Serial No. 08/654,760

For: VERTICALLY INTEGRATED FLASH EEPROM FOR GREATER DENSITY AND LOWER COST

SUPPLEMENTAL AMENDMENT

FIG. 33
SECTION A-A'

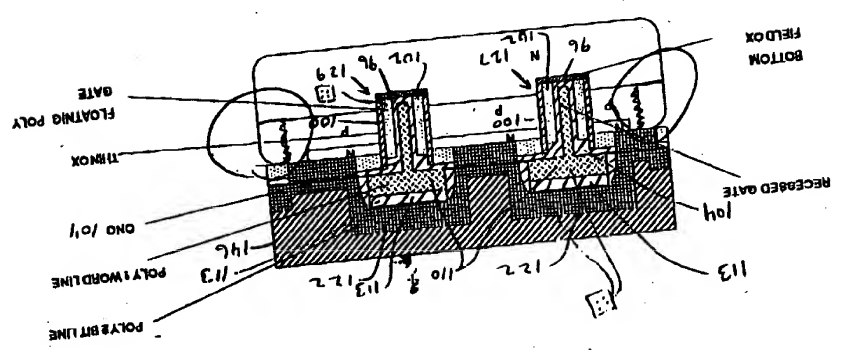
Enclosed is a markup of Figure 33 for approval by the Examiner.

The undersigned noticed, after filing the amendment in response to the Office action mailed 7/15/97 on 11/15/97, that one of the drawings showing a cross section of the finished device has an error. Specifically, the error is that bit line 122 is shown as shorting the P region acting as the transistor channel region to the N regions acting as

the source and drain. This short occurs because the P-type channel region and the N-type source region are shown as coming to the surface which they should not do at least in the vicinity on the surface where the bit line will short them together. The undersigned believes that those skilled in the art will appreciate this fact, and, since Figure 5 shows a correct cross section of the completed device, no new matter issue is raised by this change.
